PERMIT: CPDW 00 CP MOBILE HOME DOUBLEWIDE

**Harnett County Inspection Department**

Job Name: CHOOS Date: 8-22-7

REF: Ronnie Miller Res.  
101 Willamsburg Way  
Cameron, NC 28321

TE DOWN LOCATIONS

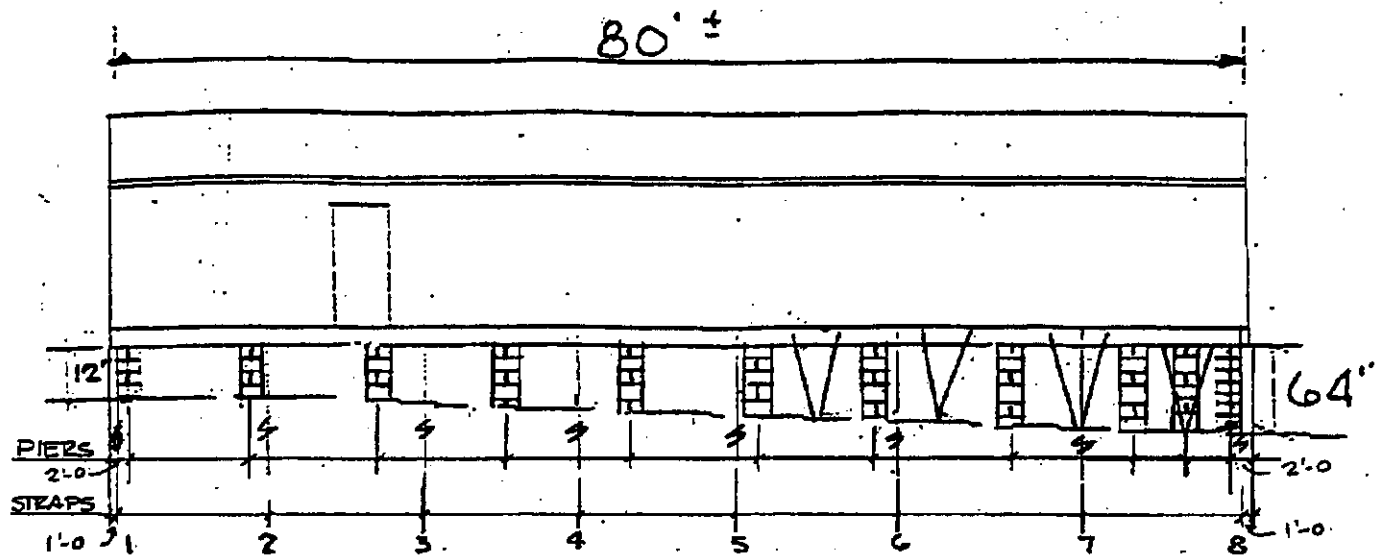
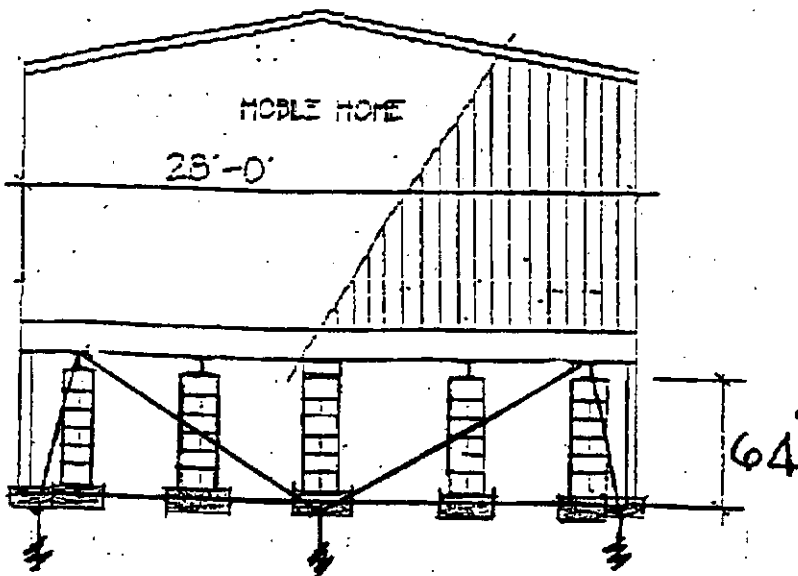
I made an onsite inspection of the doublewide mobile home referenced above. The highest point of the chassis above the existing grade was approximately 64 inches. The existing tie downs and piers are adequate, see sketch. Based on the materials and construction procedures used, the above mobile home is anchored adequately to resist the wind pressure in the area. The piers, footings and tie down straps meet or exceed the requirements set forth in the N.C. Regulations for Manufactured Homes, 2004 edition.

I always suggest that after about six months, when the home has had time to settle, that all of the hold down straps be retightened.

TIE DOWN LOCATIONS

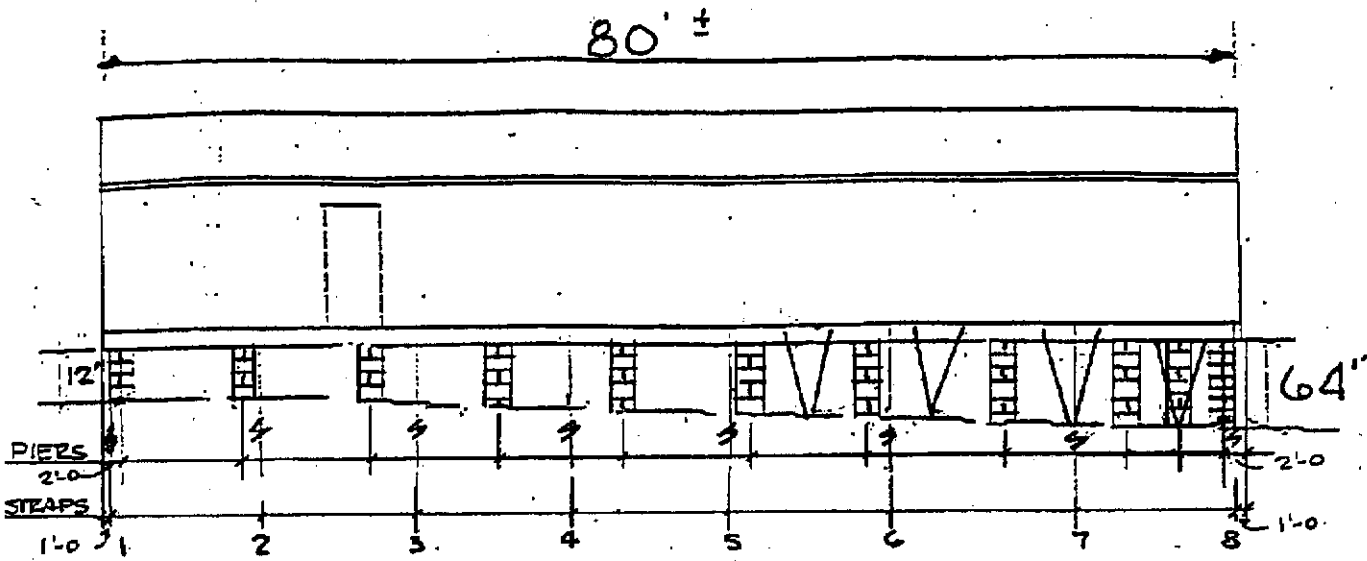
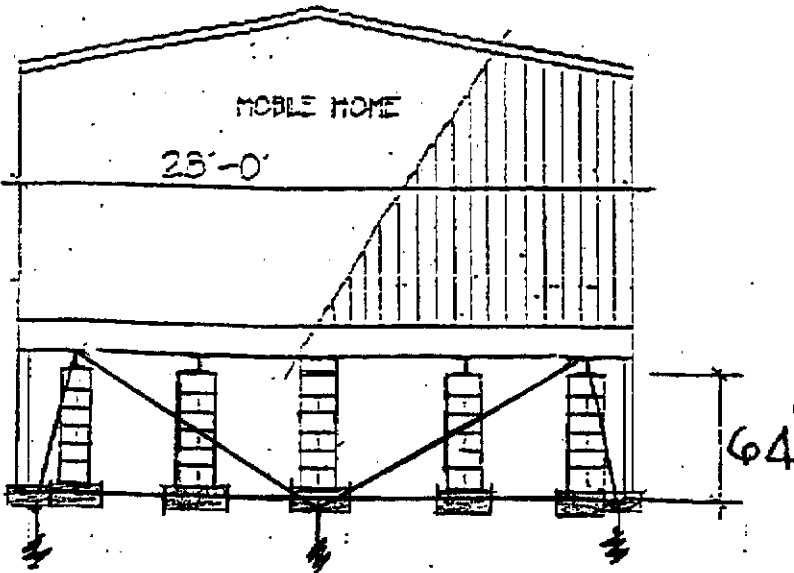
I made an onsite inspection of the doublewide mobile home referenced above. The highest point of the chassis above the existing grade was approximately 64 inches. The existing tie downs and piers are adequate, see sketch. Based on the materials and construction procedures used, the above mobile home is anchored adequately to resist the wind pressure in the area. The piers, footings and tie down straps meet or exceed the requirements set forth in the N.C. Regulations for Manufactured Homes, 2004 edition.

I always suggest that after about six months, when the home has had time to settle, that all of the hold down straps be retightened.
